CITY OF ALBUQUERQUE

May 29, 2015

RE: Dreamstyle Warehouse, 1525 Renaissance Center Grading and Drainage Plan Engineer's Stamp Date 5-04-2015 (File: F16-D051A)

Based upon the information provided in your submittal received 5-05-15, the above referenced Grading and Drainage Plan cannot be approved for Building Permit until the following comments are addressed:

ENGINEER'S SEAL	TRACT 9A	DRAWN BY BJF
OUT TREE	RENAISSANCE CENTER GRADING AND	DATE 05/04/15
	DRAINAGE PLAN	2015009-GRB
THE STONAL	5571 MIDWAY PARK PLACE NE ALBUQUERQUE, NM 87109	SHEET # D1
RONALD R. BOHANNAN P.E. #7868	(505) 858-3100 www.tierrawestllc.com	јов # 2015009

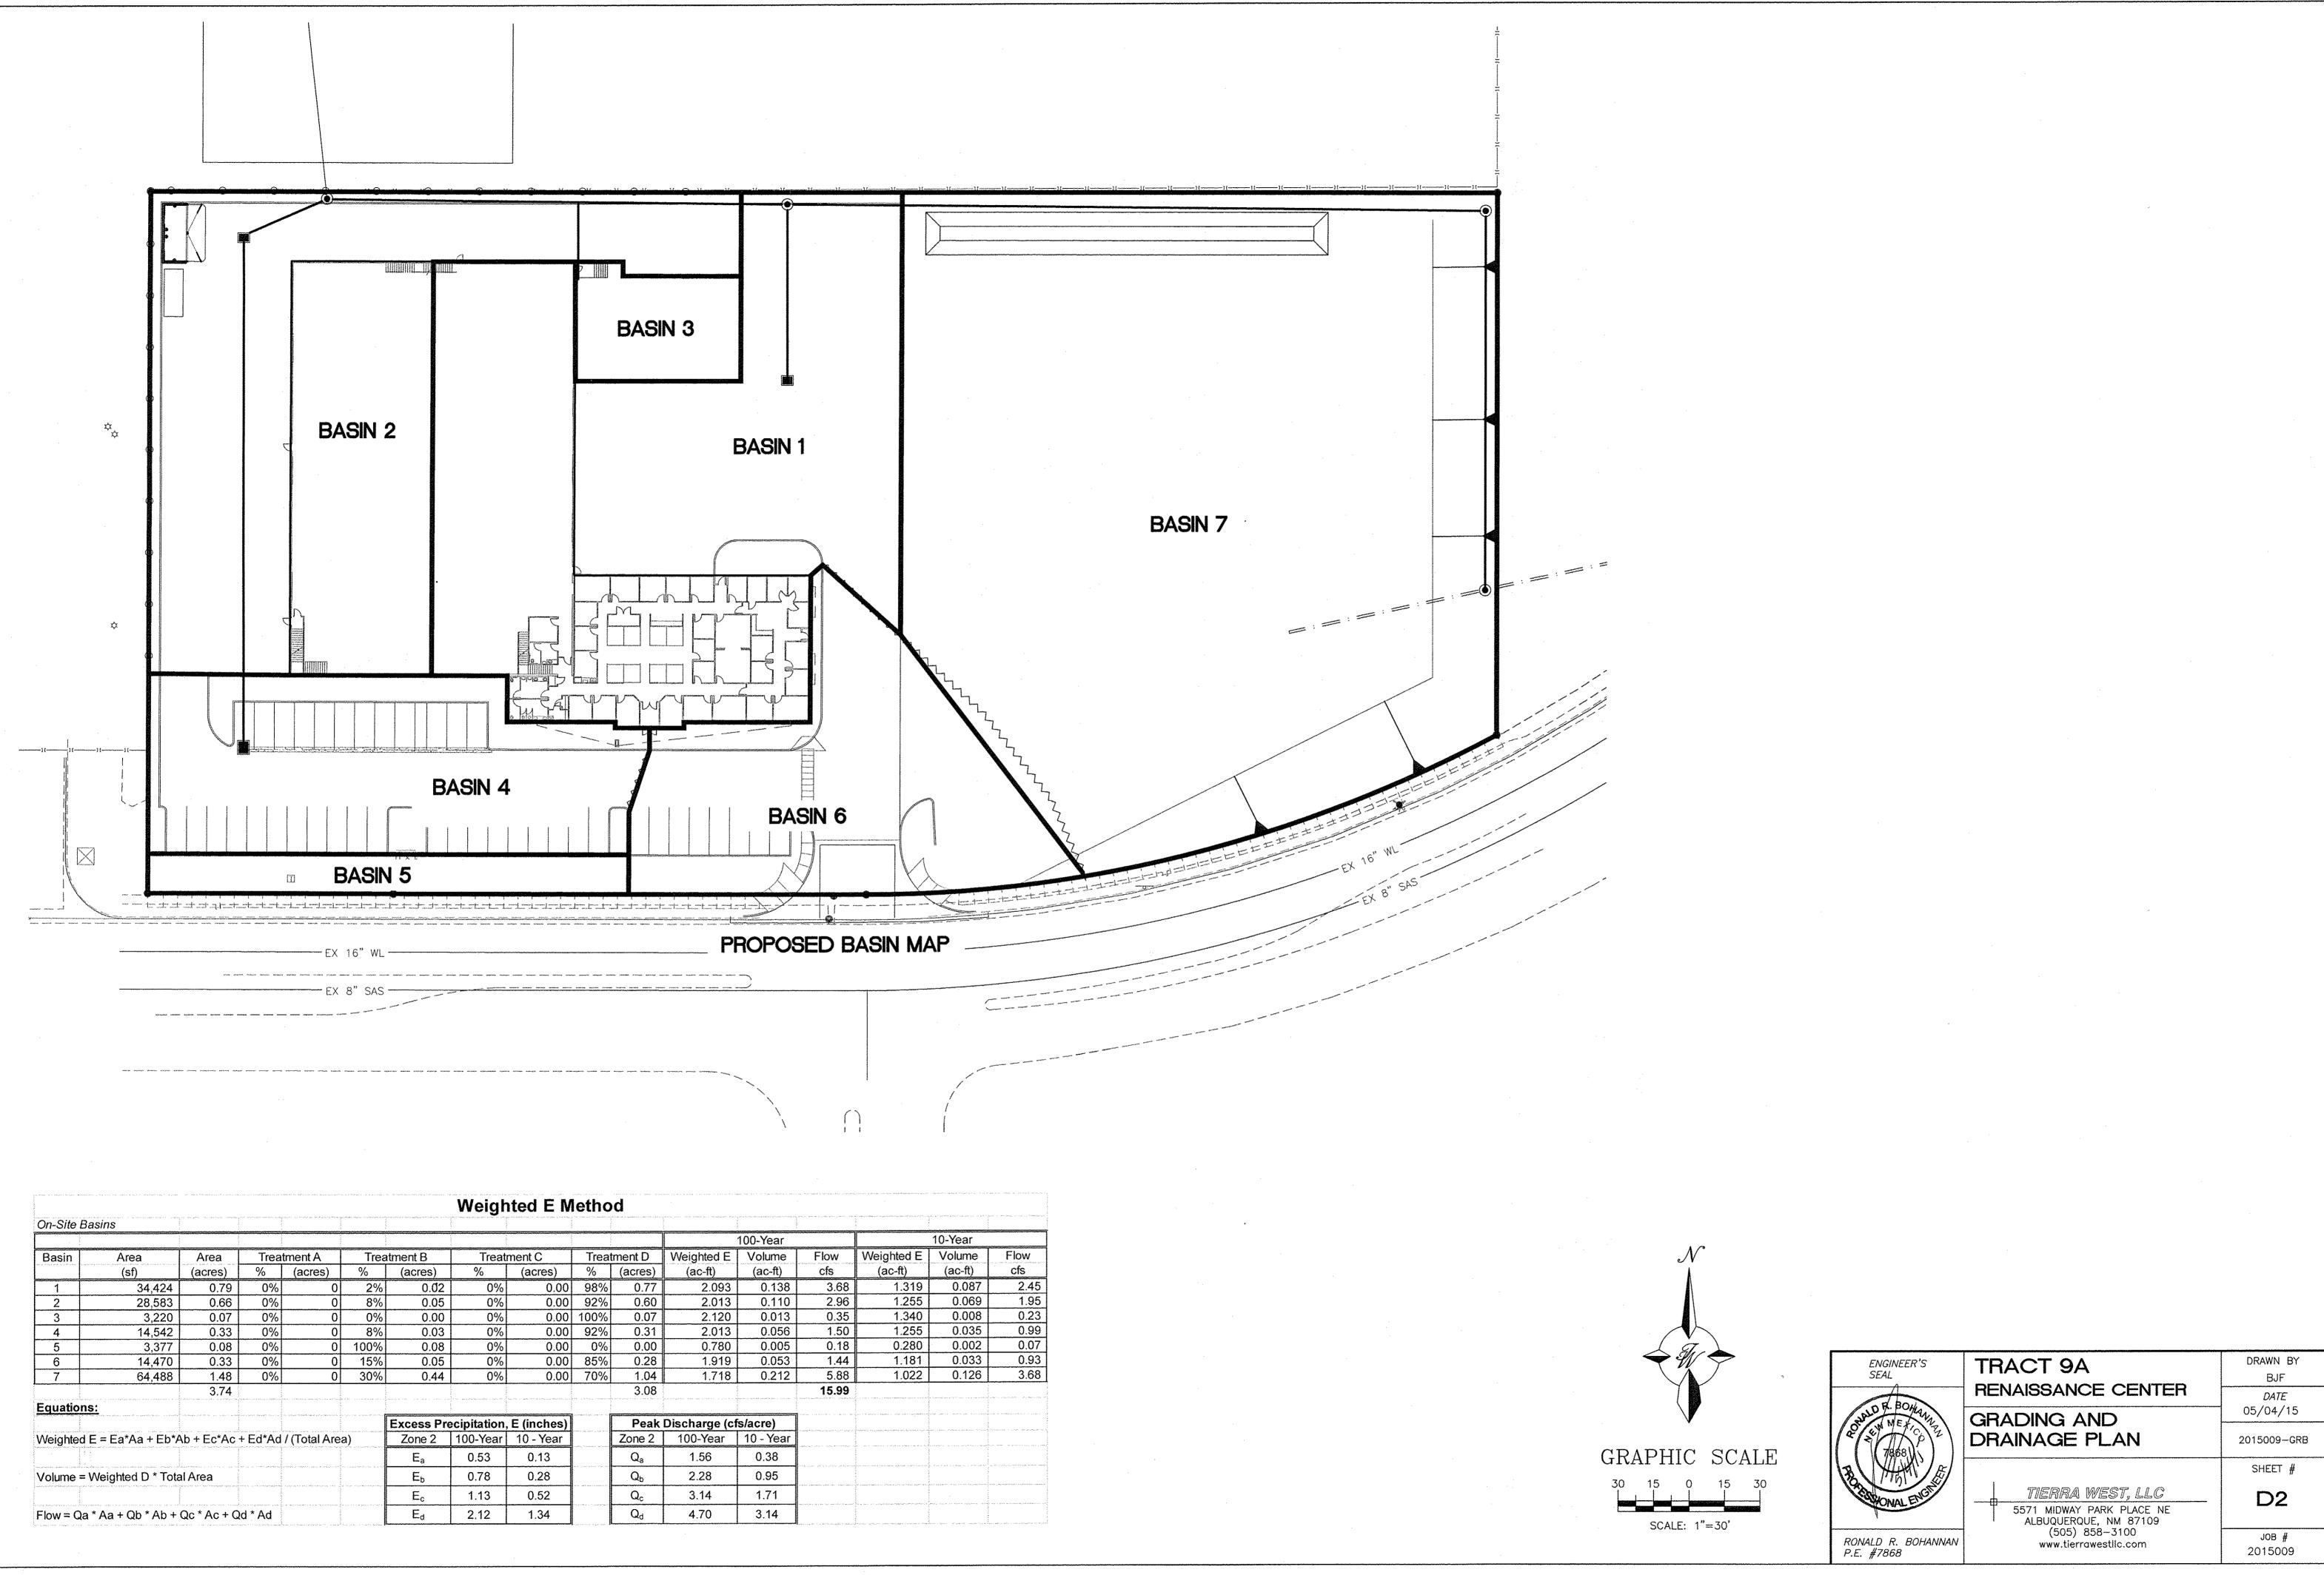
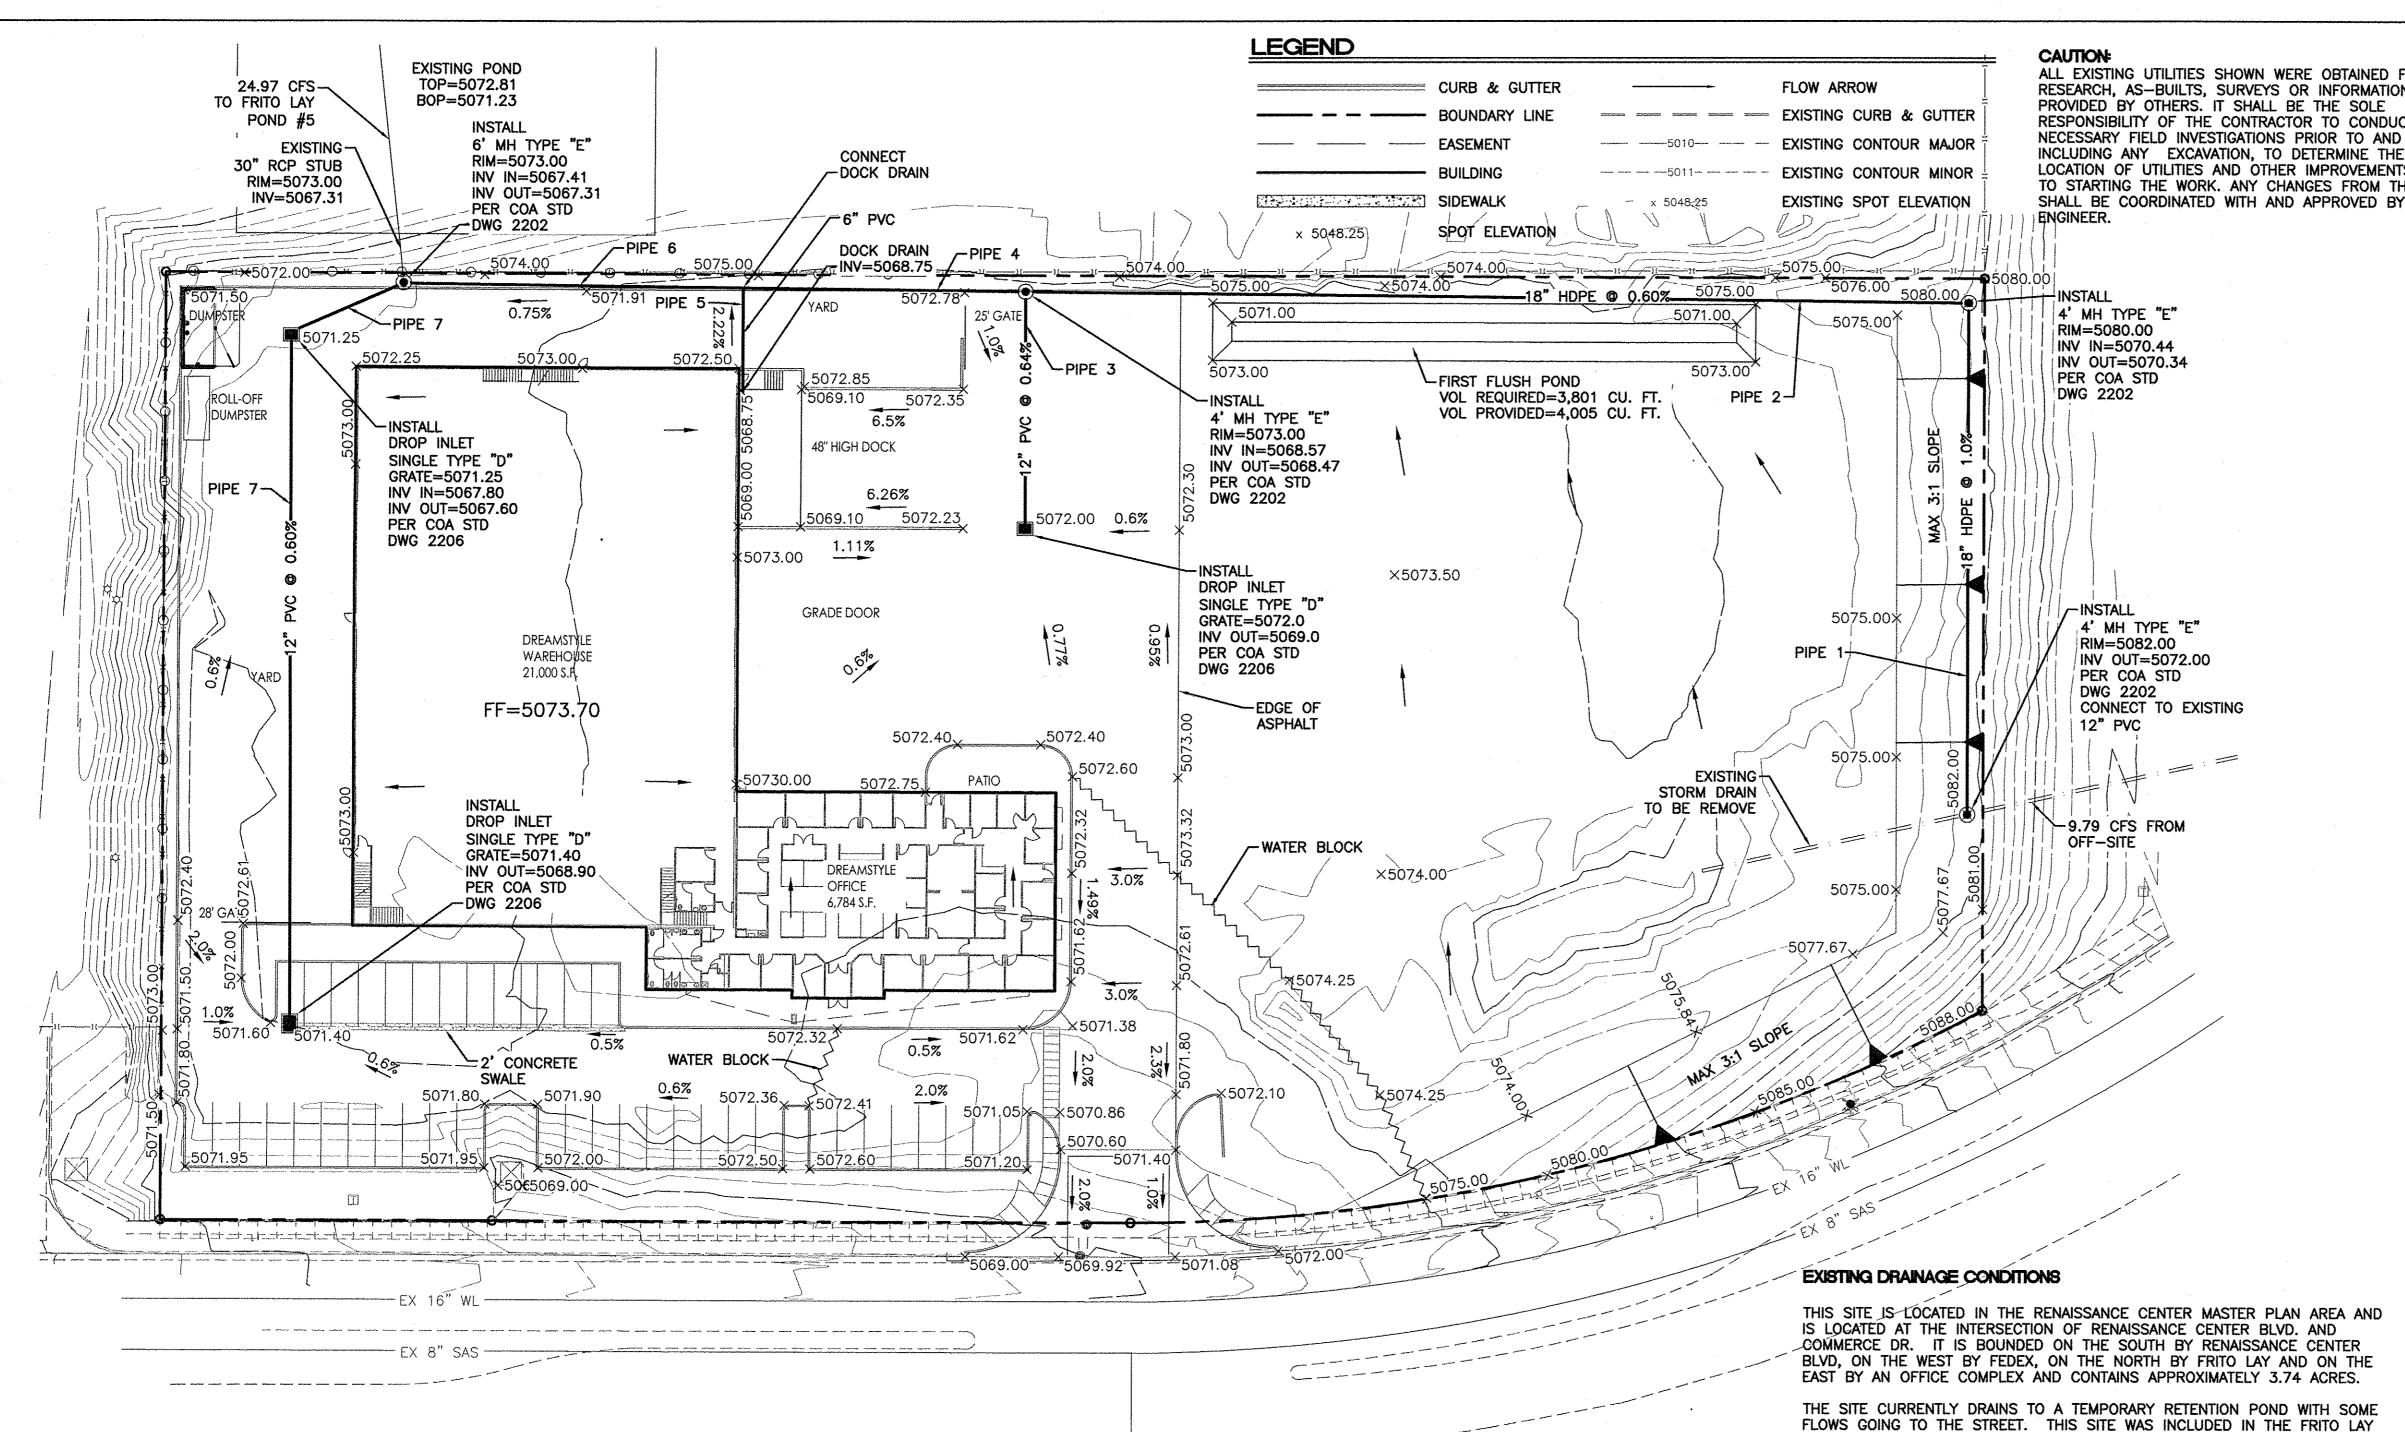
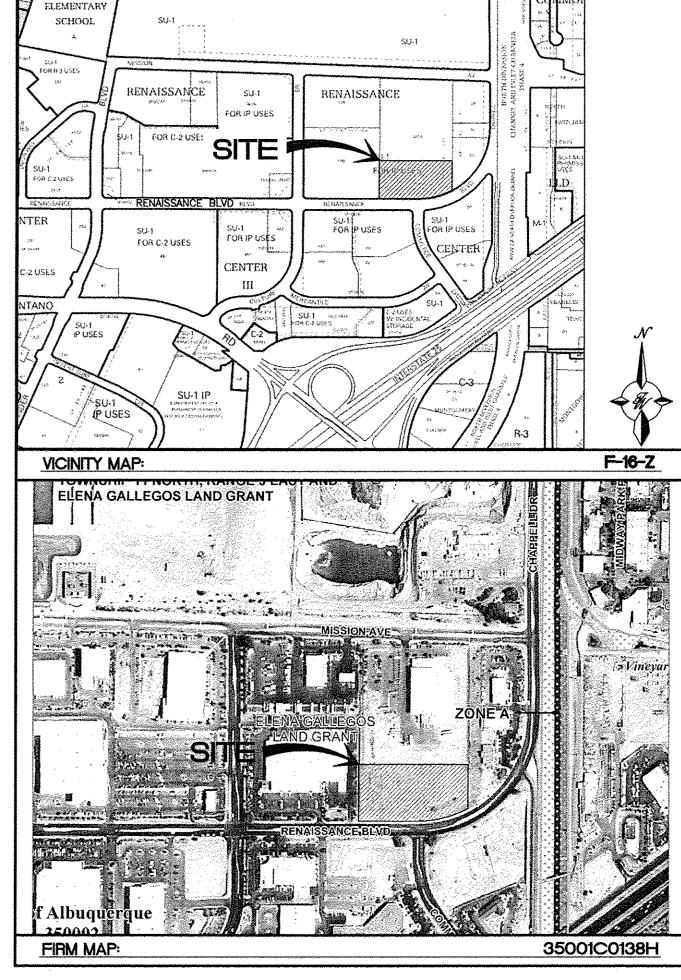
1) The First Flush Pond area must retain the impervious area of the currently proposed building at a depth of 0.34" and not be intended to only allow drainage from future impervious development on Basin 7. Show drainage from new building construction to a first flush pond area instead of directly draining it into the new storm drain system. Based on the site plan layout, some options may be to provide an area within small pervious area at the southwest corner of the building while maintaining the required minimum distance away from the building, providing a roof drain to directly tie into the currently proposed first flush pond location, and utilizing the pervious area south of the proposed parking lot. Show all roof drains for new building.

- 2) Label existing contours, particularly the major ones. Also provide new contours for the site along the 3:1 slopes.
- 3) Show existing and new contour elevations around the perimeter of the site to show how new grading ties into existing and does not adversely impact adjacent sites. Also include existing spot elevations along Renaissance Blvd, and label Renaissance Blvd. on the plan view.
- 4) Reference that the 9.79 cfs of off-site flow came from the Master Drainage Plan. In addition to the 9.79 cfs entering the site from the storm drain, address how much off-site flow is coming from the sloped area to the east of the site and show this off-

site basin area in the calculations. Call out existing pipe size that is conveying the 9.79 cfs. With this addition, maintain an overall site discharge of below 24.97 cfs to Pond 5.

- 5) For the entryway into the site, call out COA Standard Dwgs. 2426 and 2420 as applicable.
- 6) For connection of dock drain into the main storm drain, call out a tee connection and invert elevation.
- 7) Correct spot elevation showing "50730.0" at the corner of the building to correct elevation.
- 8) If 0.66 cfs is allowed to be discharged into the street, the allowable flow should be met unless it can be shown that the street and the downstream storm drain system in Renaissance that will be capturing this flow can handle the additional 0.96 cfs.
- 9) Show capacity calculations for on-site inlets.
